General Contractor for Sterling Hall School – Campus Expansion Project

ADDENDUM #5 – JULY 28, 2026

**RESPONSES TO CLARIFICATION QUESTIONS RECEIVED (PARTIAL) +
ARCHITECTURAL ADDENDUM #3**

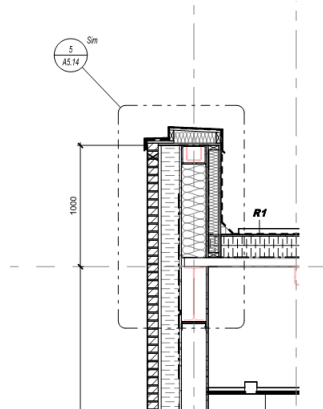
26. The drawings and details are not the greatest. It's not easy to get the details in the drawings. Not sure if any other trade has brought this up, but there are some detail references in the drawings that are not available in the Architectural drawings. As an example detail 5-A5.14, snapshot below. There is no drawing sheet A5.14. Elsewhere, there are other references to details in sheets A5.13, A5.12, A5.15, but there are no sheets A5.13 and A5.12, A5.15.

Please see additional and revised drawings as a part of this Addendum.

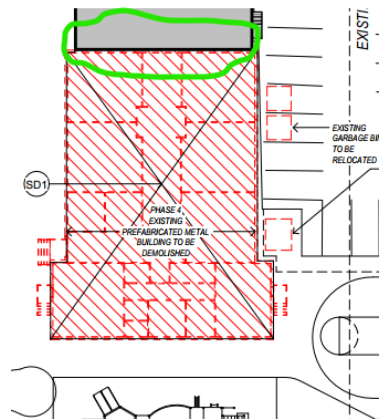
68. Does the Existing Pre Fabrication Metal Portion of the Building to be Demo'd require Fire Protection Capp off? See below Circled in Green. Does Existing Fire Protection Main require to be cap'd off here to allow for Demolition? – No Demo shown on Fire Protection Set

Yes, capping of existing system at portables for demolition is required.
